UNITED STATES PATENT AND TRADEMARK OFFICE

APPLICATION NO.	FILING DATE	FIRST NAMED INVENTOR	ATTORNEY DOCKET NO.	CONFIRMATION NO.
10/710,275	06/30/2004	Bruce Matthew Dunham	148026	4274

Office Action Summary	Application No. 10/710,275	Applicant(s) DUNHAM, BRUCE MATTHEW	
	Examiner Jurie Yun	Art Unit 2882

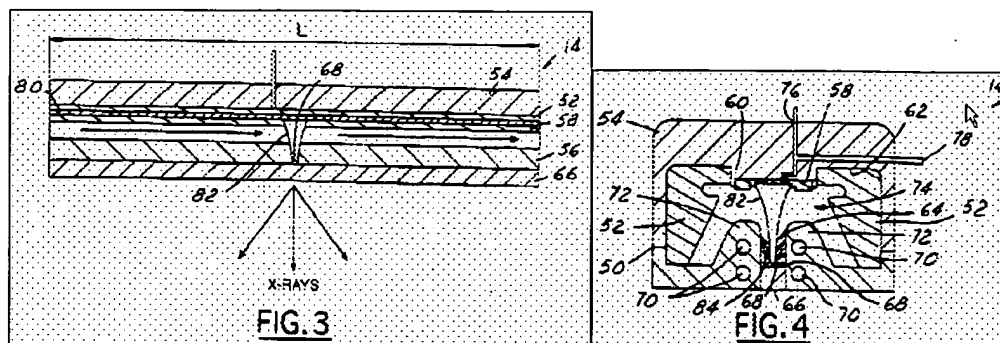
6. With respect to claims 1, 5, 8, 9, 15, 16, 23, and 25, Dunham et al. disclose an electron emitter assembly comprising: a light source configured to emit light; a plurality of photo-responsive devices and a plurality of electron emitter devices (Fig. 3, 80), each photo-responsive device being operably coupled to a corresponding electron emitter device, each photo-responsive device inducing the corresponding electron emitter device to emit electrons in response to the photo-responsive device receiving at least a portion of the light; and an anode (68) receiving the emitted electrons from each of the electron emitter devices (column 4, line 54 – column 5, lines 1+). Dunham et al. disclose (column 4, line 61 – column 5, line 19):

7. With respect to claims 2, 10, and 24, Dunham et al. disclose the anode is configured to emit x-rays in response to receiving the emitted electrons from the electron emitter device (the emitted X-rays are shown in Fig. 3 above).

8. With respect to claims 3 and 11, Dunham et al. disclose a housing (50) having a light receiving window configured to allow light from the light source to pass therethrough, the photo-responsive device and the anode (68) being disposed in the vacuum housing wherein the photo-responsive device is positioned to receive the light from the light source, the vacuum housing further comprising an X-ray transmissive window (66) being disposed in an aperture extending through a wall of the housing, wherein the anode emits X-rays (Fig. 3) through the X-ray transmissive window in response to receiving the emitted electrons from the electron emitter device.
